PO Box 881, Morwell, Victoria 3840, Australia Ph + 61 (0) 3 5172 1200 Fax + 61 (0) 3 5172 1201 www.mahindraaerospace.com SB-GA8-2019-195

Service Bulletin

Relocation of Alternate Air Induction Electrical Connection

Figure 1: Modified configuration. Additional cable ties are not shown.

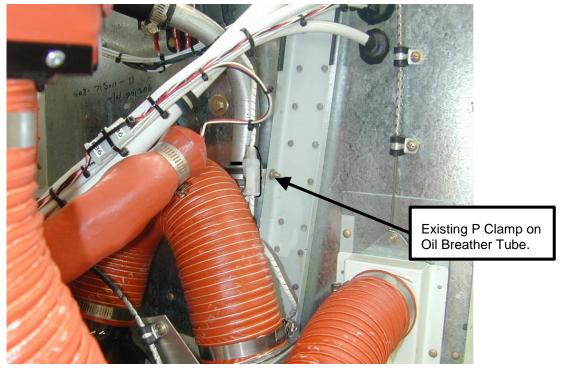
The existing restraint of the Alternate Air Induction Harness connector has been found to result in accelerated aging of the associated wiring due to vibration. This Service Bulletin addresses this issue by relocating the connector and securing it to rigid structure.

- 5. Secure harness connector to P Clamp / Oil Breather Tube as identified in Figure 1. Restrain with Item 1 per Figure 2. Trim all cable tie tails flush.
